MEMORANDUM

Subject: Campus Planning Committee Meeting, December 10, 2015

**1. Oregon Bach Festival (OBF) Music Building Addition Project - Check-in**

Oregon Bach Festival Building Addition to the School of Music and Dance  
Campus Planning Committee - Meeting 3 December 10, 2015

*An equal-opportunity, affirmative-action institution committed to cultural diversity and compliance with the Americans with Disabilities Act*

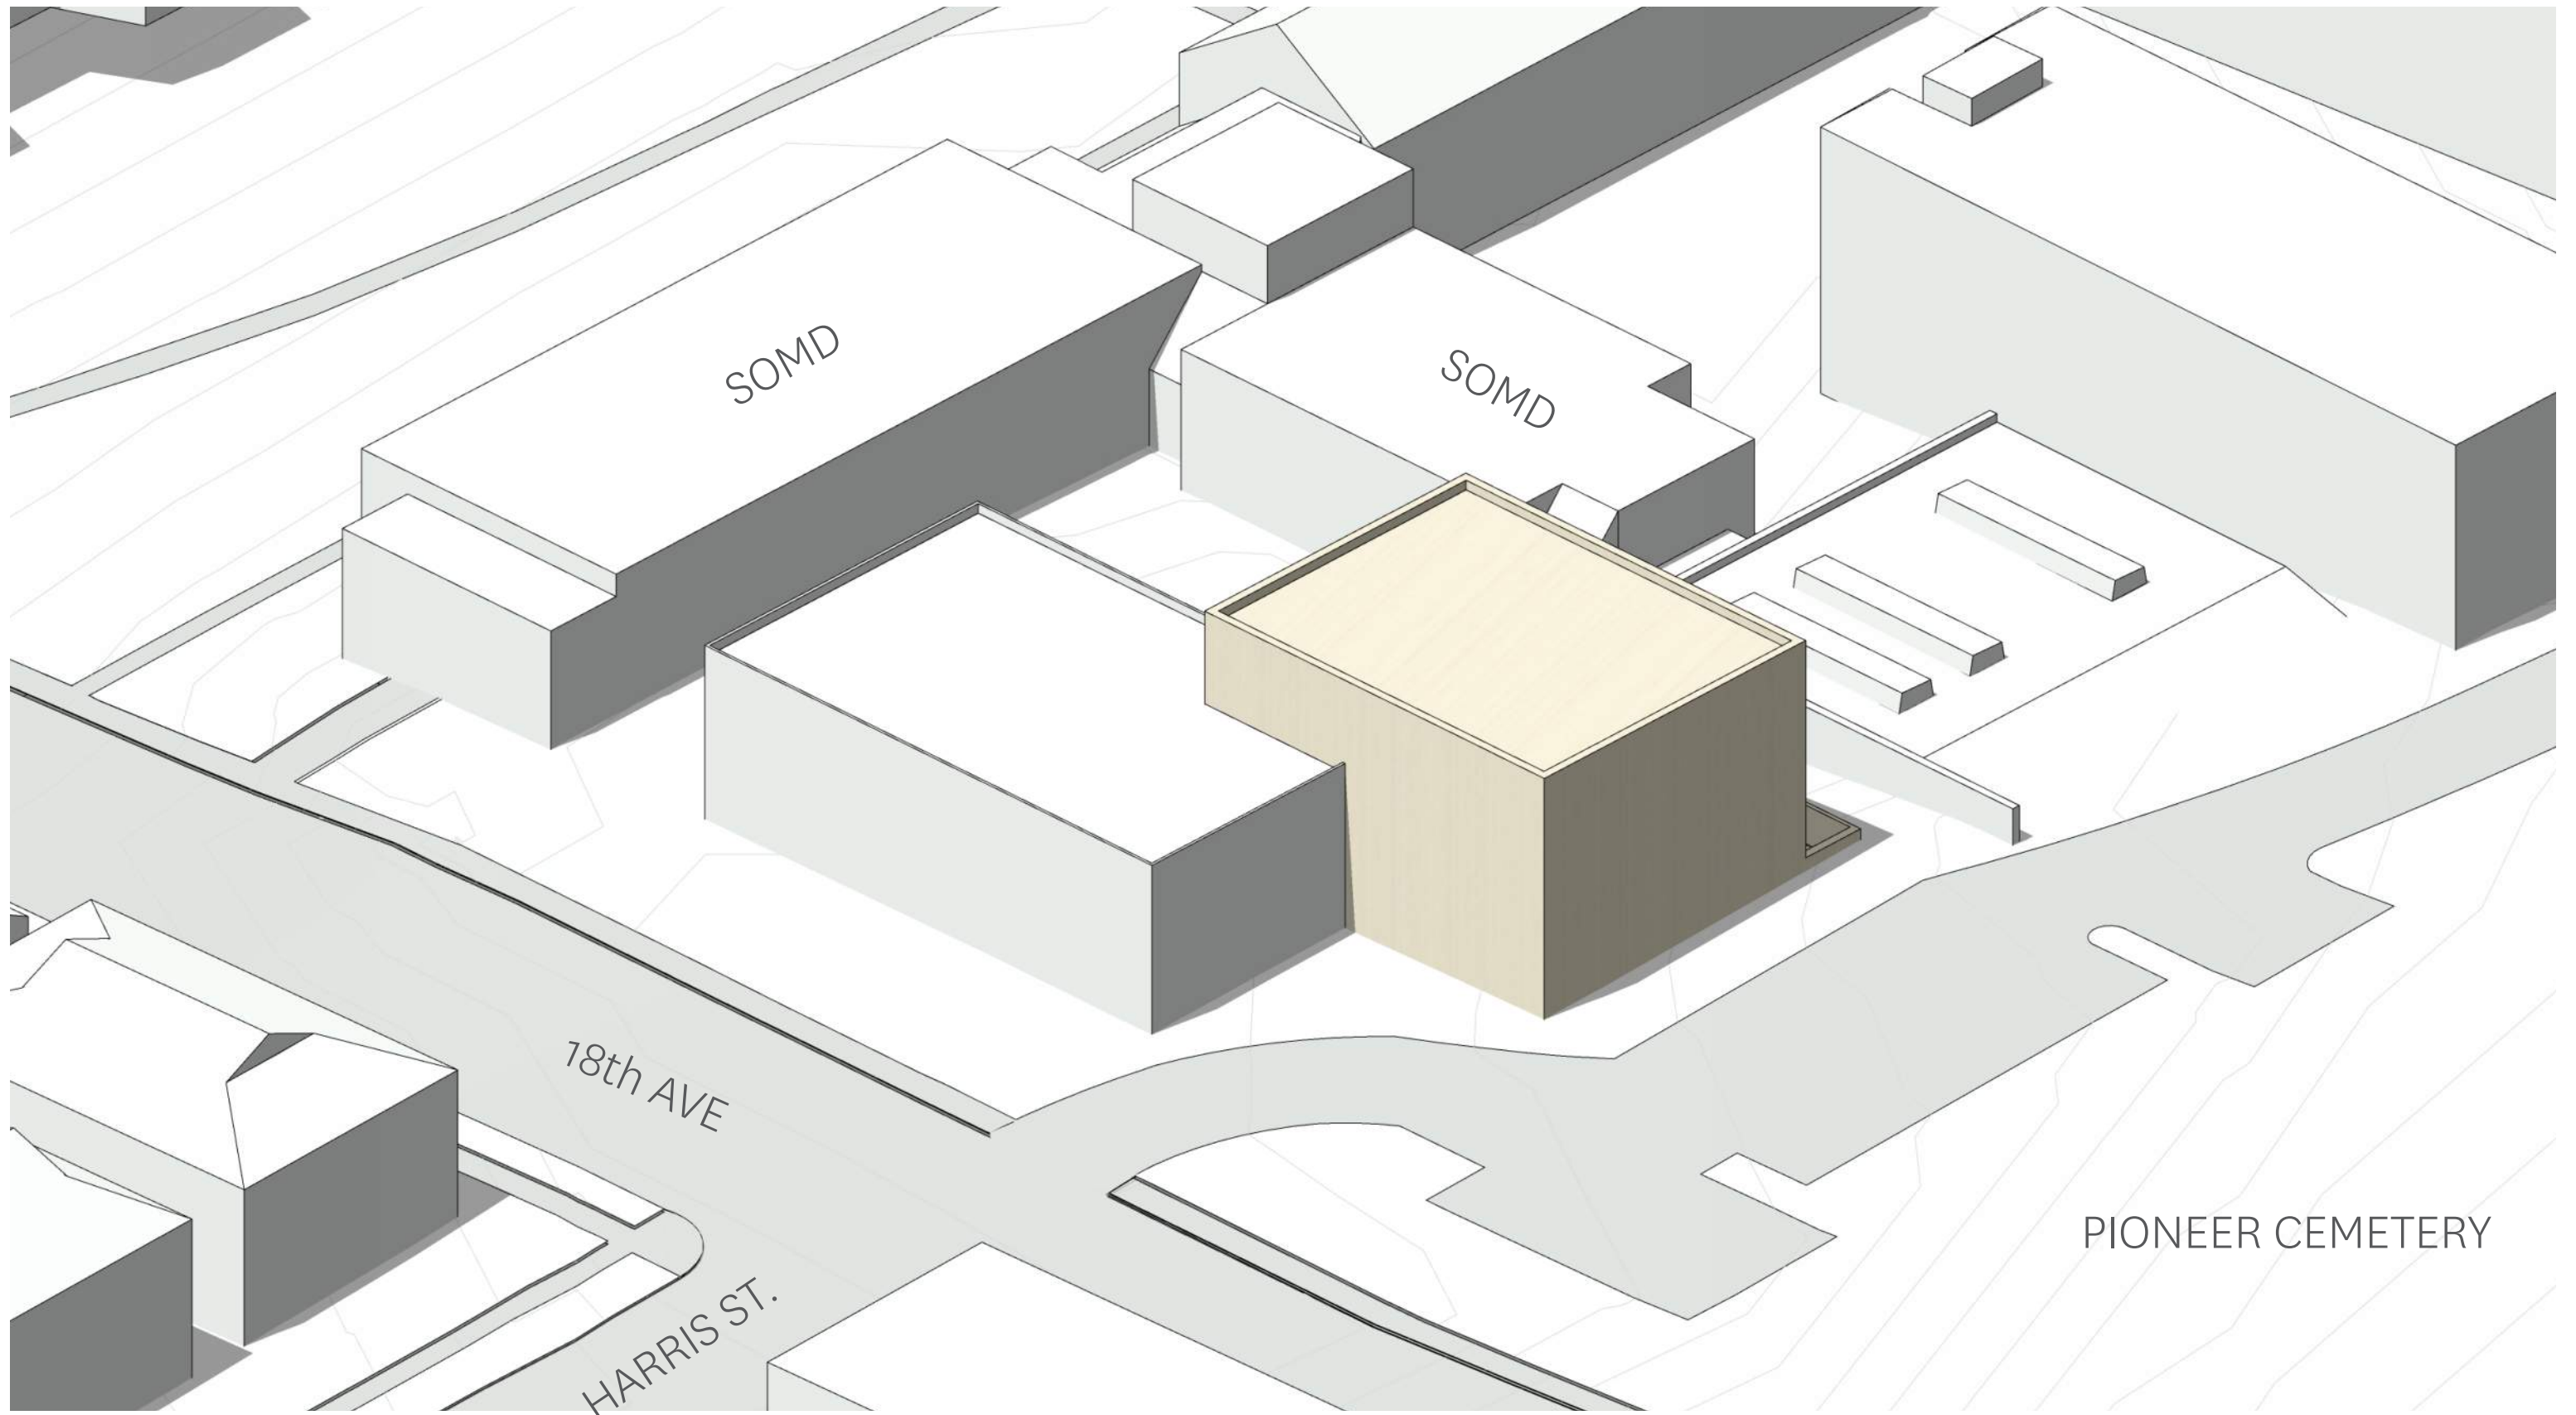
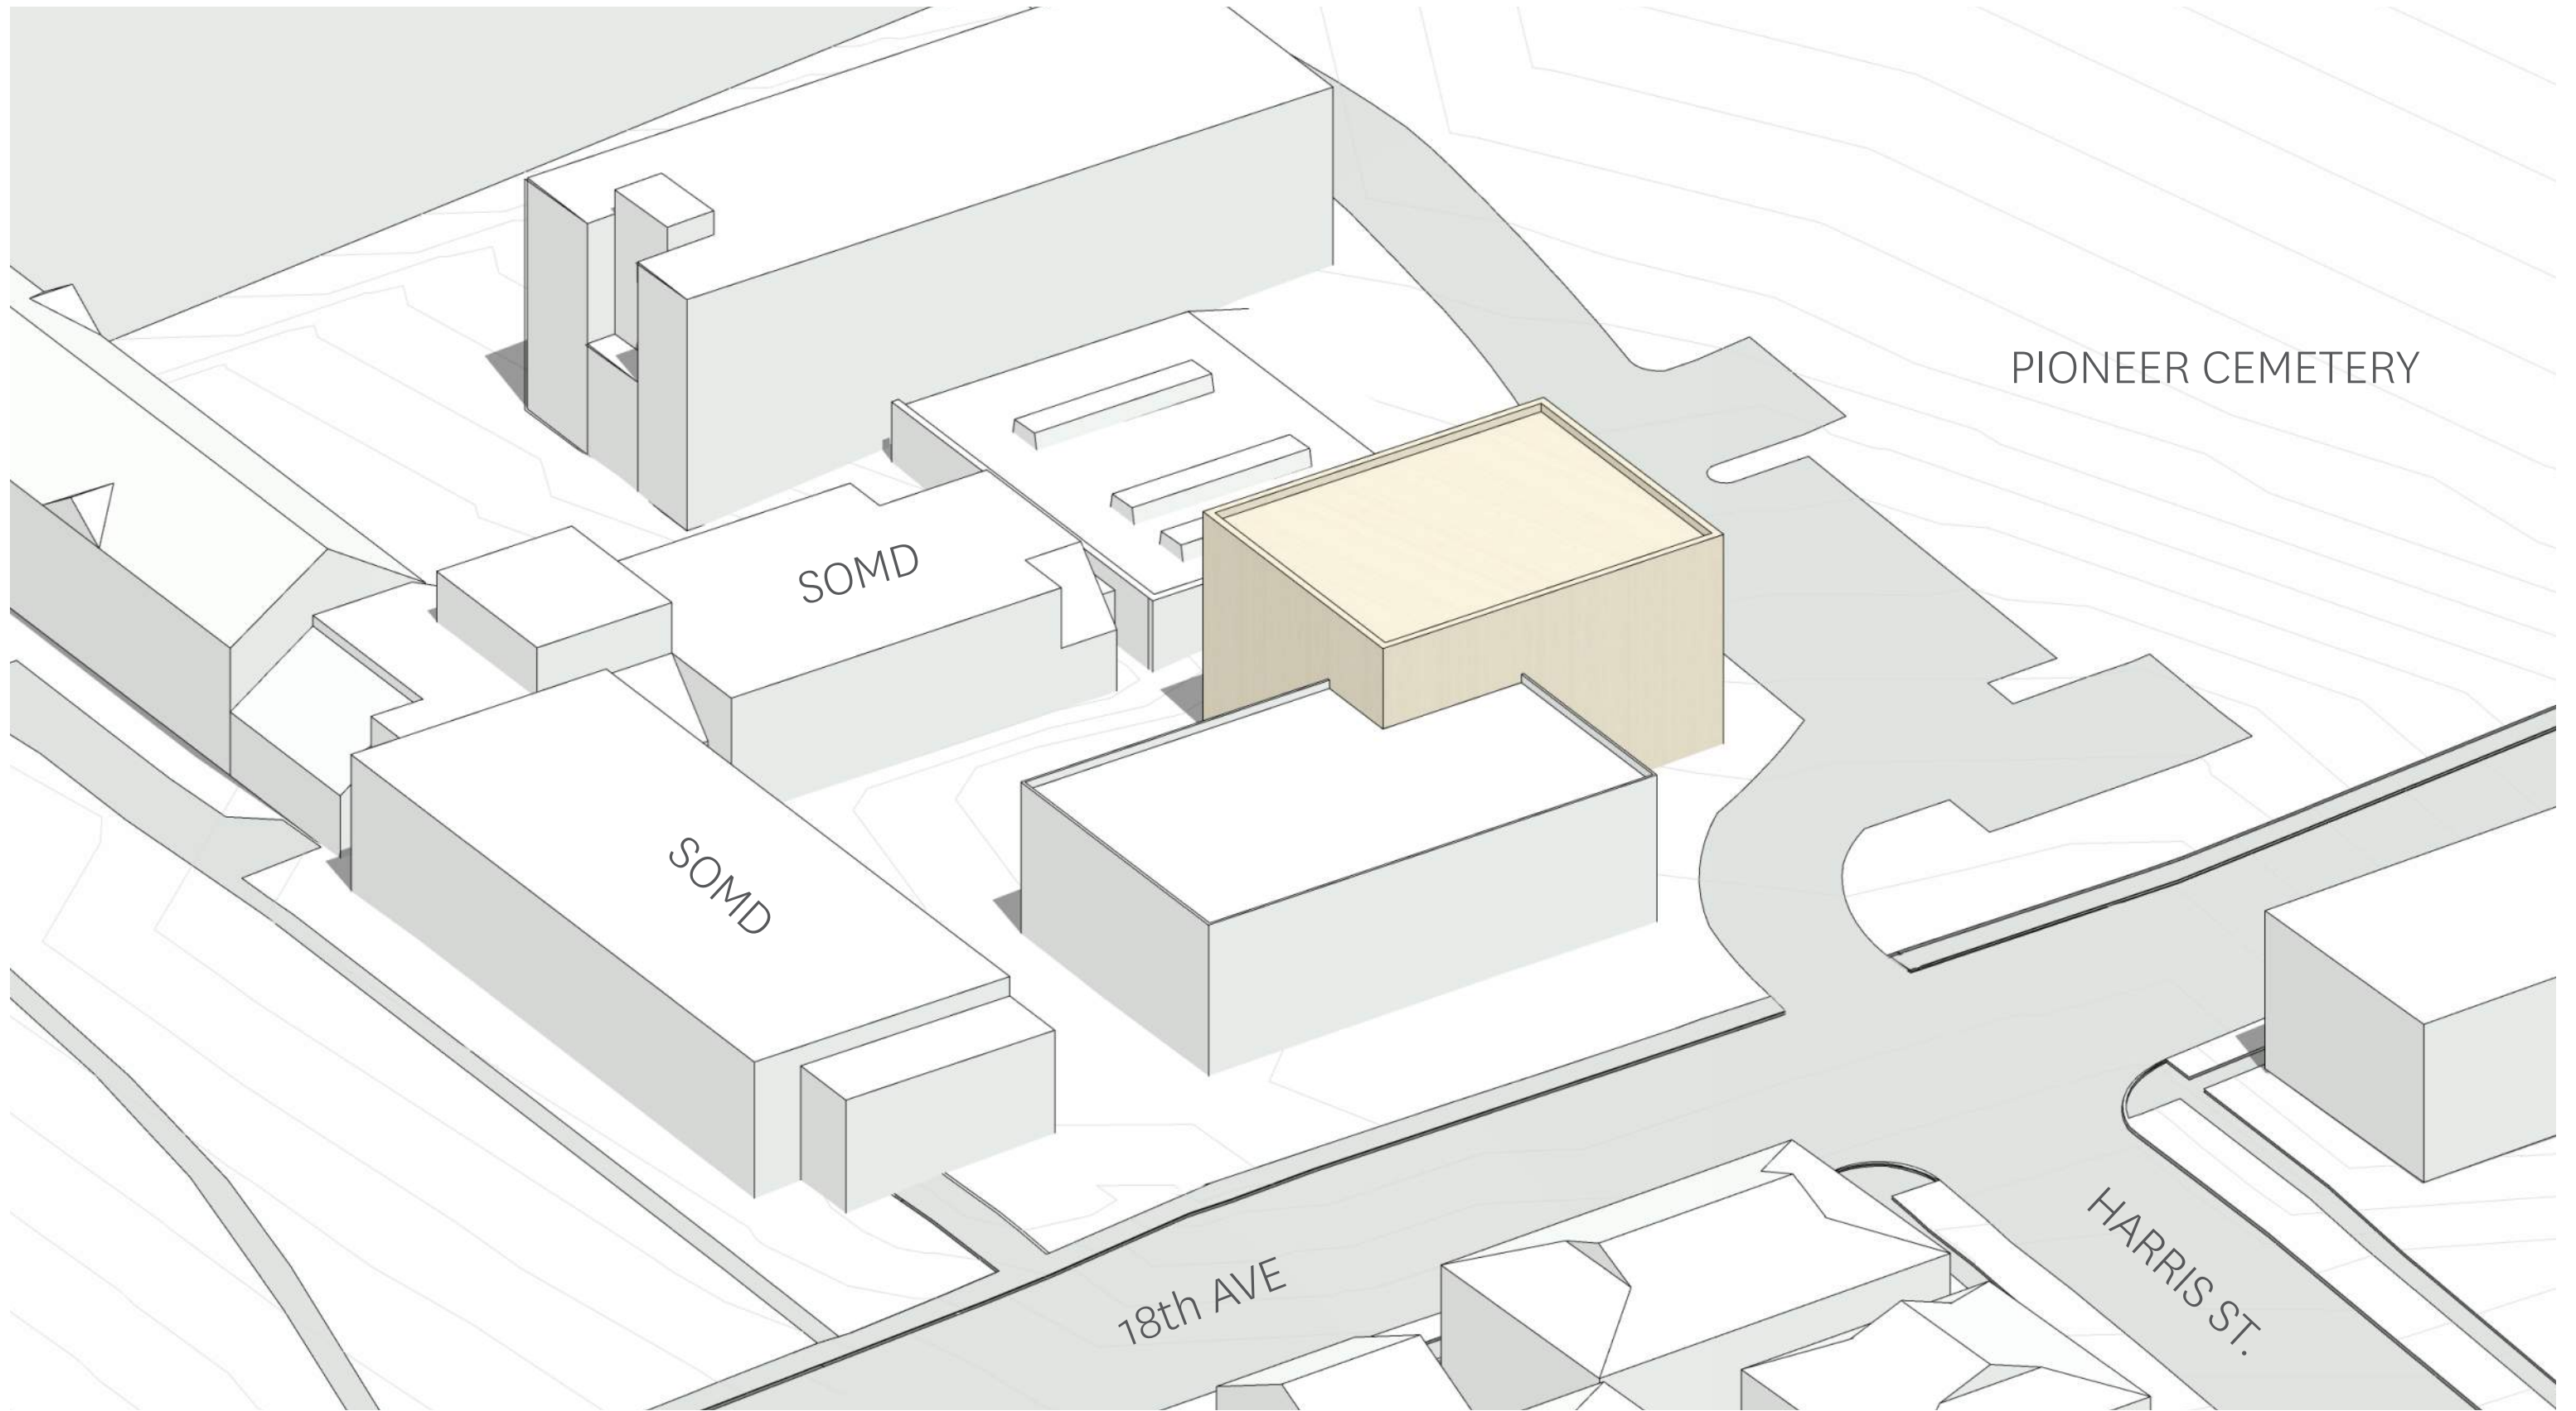
- Research options to move covered bike parking closer to building entrances in a more convenient location for regular cyclists. Keep in mind the UO Transportation Policy, which prioritizes bike parking over vehicular parking. One possible location to consider is north of the proposed addition near (or on) the existing green roof. Proximity to entrances is more important than being in direct public view.

- Regarding Policy 10: Sustainable Development, consider solar panels on the proposed addition, which seems well positioned for solar access.
- Reassess the proposed development's relationship to the 18th Avenue streetscape (e.g., the existing Music Building façade, designated open-space, drive, and Pioneer Cemetery). The proposed addition should be integrated into the existing building complex versus the dominant feature.

- Carefully assess proposed changes and improvements to the drive. Consider its relationship to the existing designated open-space and circulation network. If pedestrian travel is encouraged along the drive, improvements along the entire route to the Southwest Green should be considered, not just a portion.

- Carefully consider treatment of the Pioneer Cemetery edge. While not UO-owned, it is an important open-space element and should be treated as such.
- Reconsider the merits of the proposed "tipped" rehearsal building. Buildings that are not aligned with the campus's orthogonal structure are generally not acceptable unless there is a very compelling reason.

- Reassess ways to enlarge the new courtyard by reorienting and shifting the proposed addition further east. Ensure that the courtyard is a welcoming and functional positive outdoor space.

- Ensure access needs for the 100-140 capacity rehearsal hall are addressed.
- Keep in mind the need to transport instruments from the parking area and Music Building.
- Reassess the possibility of shifting the drive entry further east to resolve limited development space and simplify pedestrian/bike circulation (recognizing the need to work with the City).
- Consider ways to decrease and/or shift the number of parking spaces adjacent to the proposed addition to resolve pedestrian circulation and enhance landscaping connections to Pioneer Cemetery.
- Account for service access.
- Carefully assess ways to create more direct and clearer routes for pedestrians and bicyclists traveling from 18th Avenue along the north/south drive as well as to the existing Music Building and proposed addition entrances.

The project team has revised the site plan and building layout, in response to the feedback received at the first check-in meeting. The project is coming to the committee on December 10 as a second check-in meeting. The project team has revised the site plan and building massing configuration in response to the feedback received at the first check-in meeting on November 16, 2015, described below.
